ZONING CHANGE REVIEW SHEET

CASE: C814-97-0001.12

(Leander Rehabilitation Planned Unit Development Amendment #13)

ADDRESS: 10501 Lakeline Mall Drive

PRESIDIO III & IV - AUSTIN, TX
INTERNAL DRIVES EXHIBIT

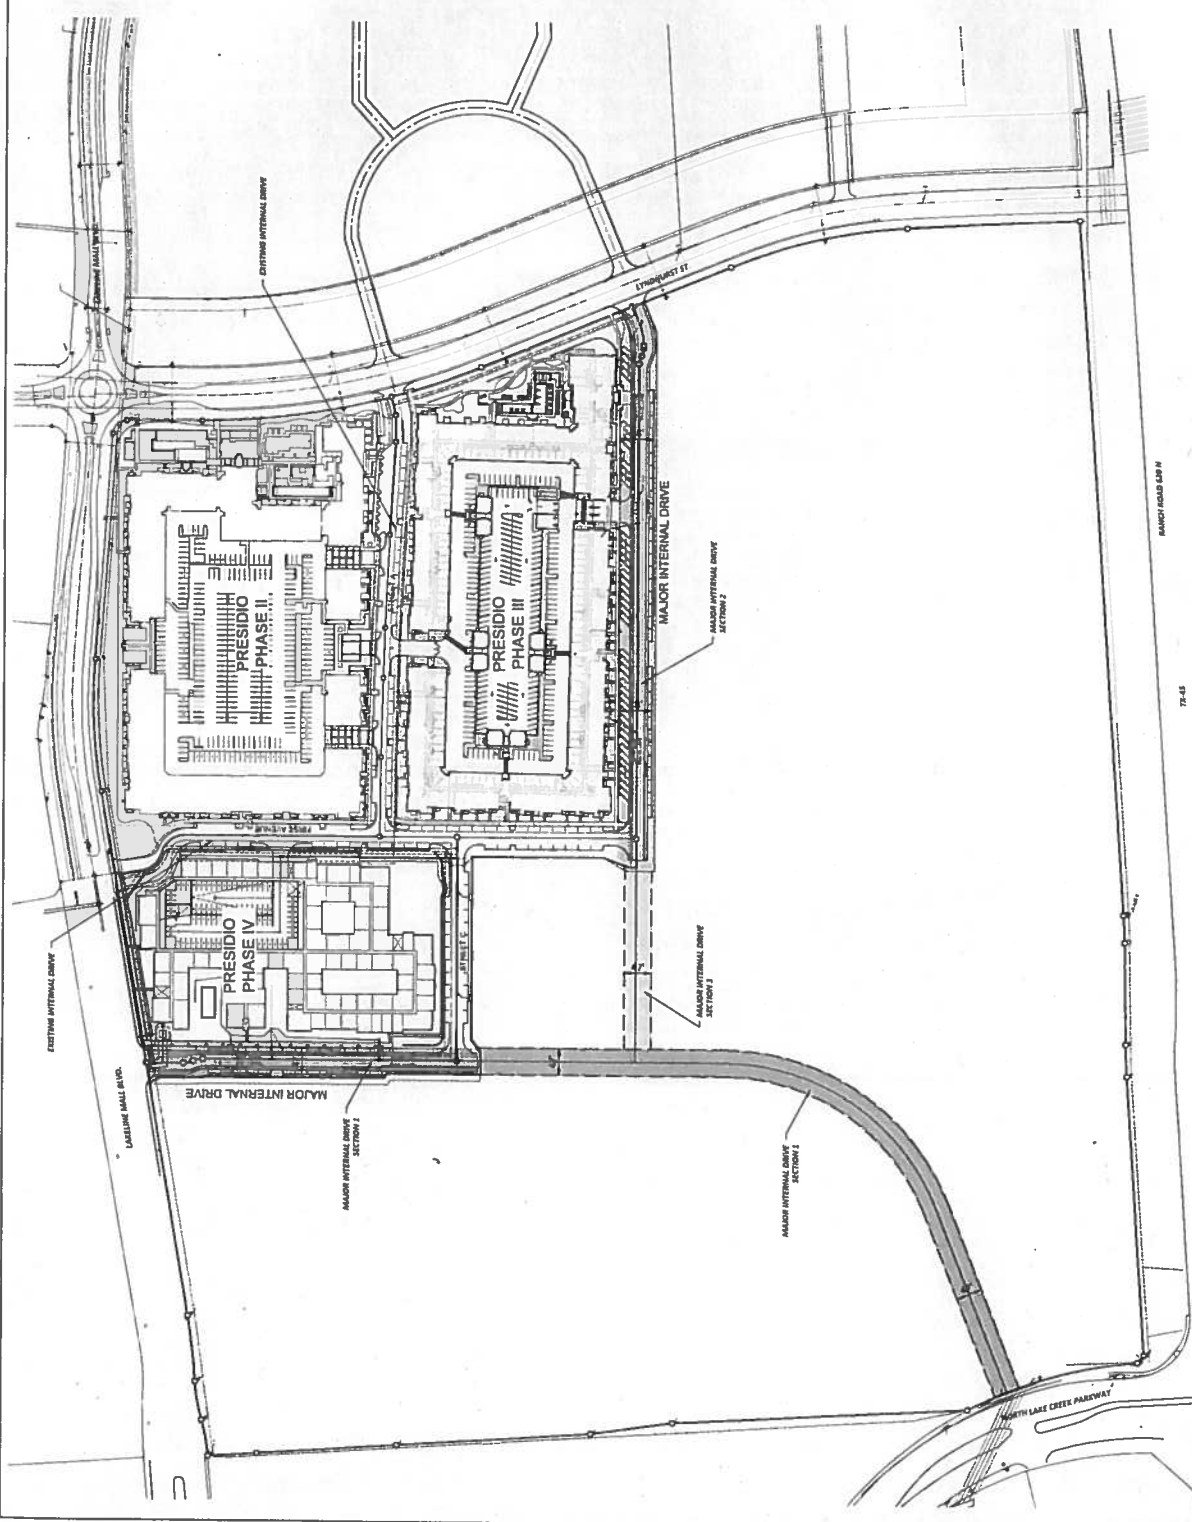
U1: Comment not cleared. ATD has approved for lots to abut a major internal drive rather than dedicated ROW, but the following conditions are required to be met.

- Exhibit with internal circulation routes and required cross sections should be added to the PUD. A note on the PUD land use plan should state that all internal drives are required to be located within public access easements and constructed to the crosssections provided in the exhibit. "Future internal drives" should either be shown as proposed drives, regardless of the timeline for construction, or removed from the exhibit.
- ATD approval of the cross-sections is required. Previously a 78' cross section was approved and the cross-sections shown here deviate from that previous approval. This reviewer has reached out to ATD for comments.
- Proposed internal drives are required to connect to each other. If the connection is to occur through Street C, then Street C needs to be expanded to include the same level of bicycle and pedestrian infrastructure.

U2: Comment not cleared. Exhibit provided via email dated 4/9/19 was approved for major internal circulation routes. Please add language to the land use plan stating that platting is permitted off major internal drives as identified in the exhibit. That all major internal drives need to be designed in accordance with the circulation/drives exhibit and all major internal drives are required to be located within public access easements. Additionally, please add the following notes to the circulation plan:

- Sidewalks, a minimum of 5' in width, are required along both sides of all major internal drives. The sidewalk may be placed adjacent to, or setback from the back of curb of the Major Internal Drive Street Section. Street trees and landscaping are encouraged where feasible; located between the sidewalk and back of curb or in tree or landscape islands located in the sidewalk.
- At connections with public roadways, additional turn lanes (left or right out) may be added to the Major Internal Drives cross Section as approved by the transportation reviewer in coordination with the Austin Transportation Department.

16. ALL MAJOR INTERNAL DRIVES SHALL BE DESIGNED IN ACCORDANCE WITH THE CIRCULATION AND DRIVES EXHIBIT.
